Metropolitan Development Commission Regional Center Hearing Examiner (January 26, 2023) Meeting Agenda

STAFF REPORT

Case Number	2022-REG-077
Address (approx.)	902, 916, 918 and 922 North Capitol Avenue
Location	Center Township, Council District # 11
Petitioner	MTP – 922 N. Capitol Ave., LLC, by Joseph D. Calderon
Zoning	CBD-S (RC)
Request	Regional Center Approval for demolition of existing buildings and construction of a five-story, mixed-use development, with approximately 270 units, 13,840 square feet of office and retail space, a parking garage with approximately 398 spaces, and resident amenities, including an outdoor courtyard.

Case Number	2022-REG-080
Address (approx.)	1740 West Michigan Street
Location	Center Township, Council District # 11
Petitioner	Miley Avenue LLC, and BMWC Constructors, Inc., by Brad Schoeff
Zoning	I-4 (RC)
Request	Regional Center Approval to provide for demolition of a 3,708-square-foot shed and a 7,083-square-foot concrete block structure and for construction of a proposed, two-story, 29,773-square-foot fabrication structure.

Floor plan – ground level

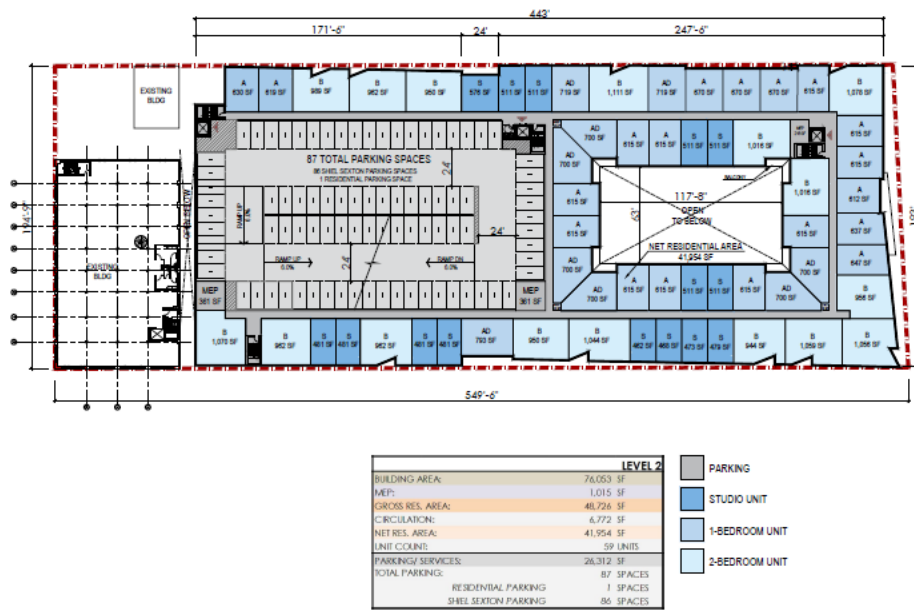
1. In consultation with the City Administrator of Long-Range Planning for Transportation, the building frontage, at the parking garage entry, should be recessed along Capitol Avenue and a right-in/ right-out designed to force vehicles to turn immediately into and out of the parking garage. Additionally, signage must be provided for appropriate information to pedestrians and drivers for staff review and approval, prior to the issuance of an Improvement Location Permit. Guidelines SC 3.3.6 and SC 3.4.3 would apply.
